IN THE UNITED STATES PATENT AND TRADEMARK OFFICE

Applicant: John T. Moy and Richard A. Barry  
Serial No: 09/760,510  
Filed: January 12, 2001  
For: SERVICE DISCOVERY USING A USER DEVICE INTERFACE  
TO AN OPTICAL TRANSPORT NETWORK

**PRELIMINARY AMENDMENT**

Fig. 4.

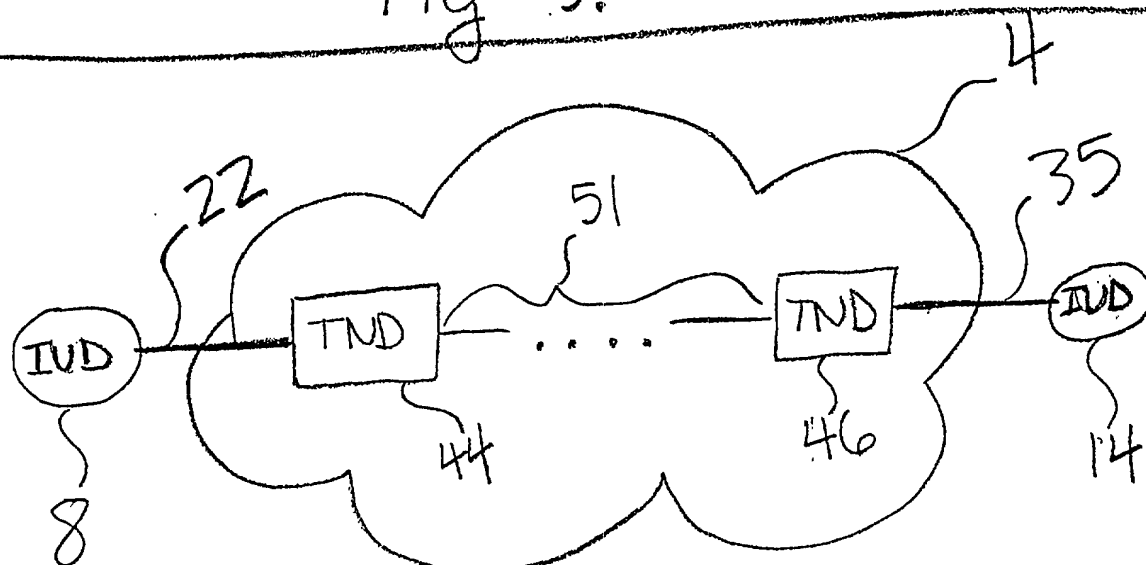
Fig. 4 is a block diagram illustrating an example embodiment of an optical trail that may be created across the OTN 4 of Fig. 1. This optical trail may include IUD 8, UDI link 22, TND 44, one or more internal links 51 and possibly one or more other TNDs of the OTN 4, [51,] TND 46, UDI link 35 and IUD 14.

Fig. 4 is a block diagram illustrating an example embodiment of an optical trail that may be created across the OTN 4 of Fig. 1. This optical trail may include IUD 8, UDI link 22, TND 44, one or more internal links 51 and possibly one or more other TNDs of the OTN 4, TND 46, UDI link 35 and IUD 14.

Fig. 5

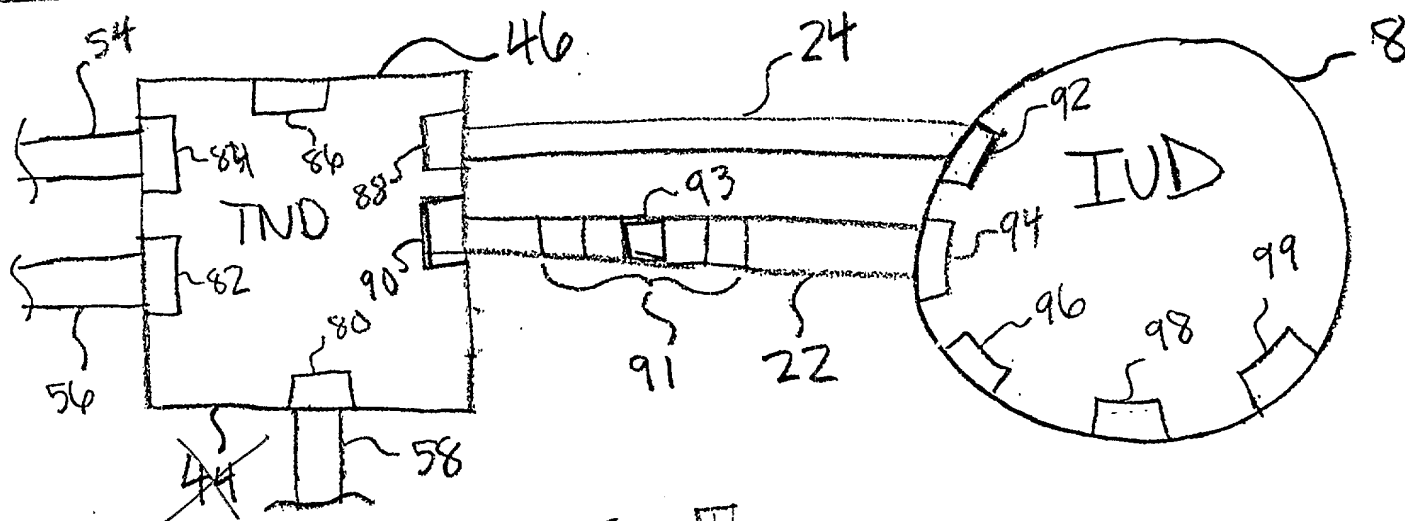
Under separate letter to the Official Draftsperson, Applicant proposes drawing corrections to Figures 1 and 5. Applicant also submits new formal drawings in compliance with 37 CFR 1.84.

To further prosecution of this application, Applicant submits Formal Drawings that comply with 37 C.F.R. 1.84. In addition, minor corrections have been made to Figs. 1 and 5 as specified in red ink on the attached marked-up informal drawings for Figs 1 and 5. These minor corrections are reflected in the Formal Drawings. No new matter has been added by these minor corrections.

Fig. 5 is a block diagram illustrating an example of an embodiment of a more detailed view of the physical interface between TND 46 and UD 8. TND 46 may include a plurality of ports 80, 82, 84, 86, 88 and 90. Port 80 may be interfaced to internal link 58, port 82 to internal link 56, port 84 to internal link 54, port 88 to UDI link 24 and port 90 to UDI link 22, and port [96] 86 may be idle.

Fig. 5 is a block diagram illustrating an example of an embodiment of a more detailed view of the physical interface between TND 46 and UD 8. TND 46 may include a plurality of ports 80, 82, 84, 86, 88 and 90. Port 80 may be interfaced to internal link 58, port 82 to internal link 56, port 84 to internal link 54, port 88 to UDI link 24 and port 90 to UDI link 22, and port 86 may be idle.
